Subject: Brunswick Steam Electric Plant, Unit Nos. 1 and 2
Docket Nos. 50-325 and 50-324/License Nos. DPR-71 and DPR-62
Response to Request for Additional Information Regarding Request for
License Amendment - Technical Specification 3.3.1.2, "Source Range
Monitor (SRM) Instrumentation" (NRC TAC Nos. MD6385 and MD6386)

Response to NRC Request for Additional Information

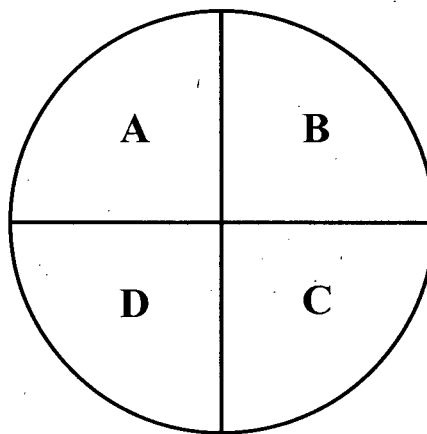
Please provide clarification that one Source Range Monitor (SRM) may be used to satisfy more than one of the above three locations in Question 1. Also, clarify that this one SRM must be operable one.

As an example, assume that core alterations are to be made in quadrant A as depicted in the following diagram.

Table 3.3.1.2-1 requires two operable SRMs to support core alterations. SR 3.3.1.2.2 and the proposed footnote (c) state that during core alterations, the operable SRMs must be located in (1) the fueled region; (2) the core quadrant where core alternations are being performed, when the associated SRM is included in the fueled region; and (3) a core quadrant adjacent to where core alternations are being performed, when the associated SRM is included in the fueled region. Both also indicate that one SRM may be used to satisfy more than one of these location requirements.

To meet the location requirements of SR 3.3.1.2.2 and the proposed footnote (c), one of the operable SRMs must be located in the quadrant where the core alteration is made (i.e., quadrant A in this example). As such, this SRM would be satisfying location requirements (1) and (2).

The second operable SRM must be in a core quadrant adjacent to where the core alteration is being performed (i.e., location requirement (3)). In this example, the second SRM must be in either quadrant B or D, provided the SRM is neutronically linked to the first SRM (i.e., a "fuel bridge" exists between the two operable SRMs). Hence, the second SRM would be satisfying location requirements (1) and (3).
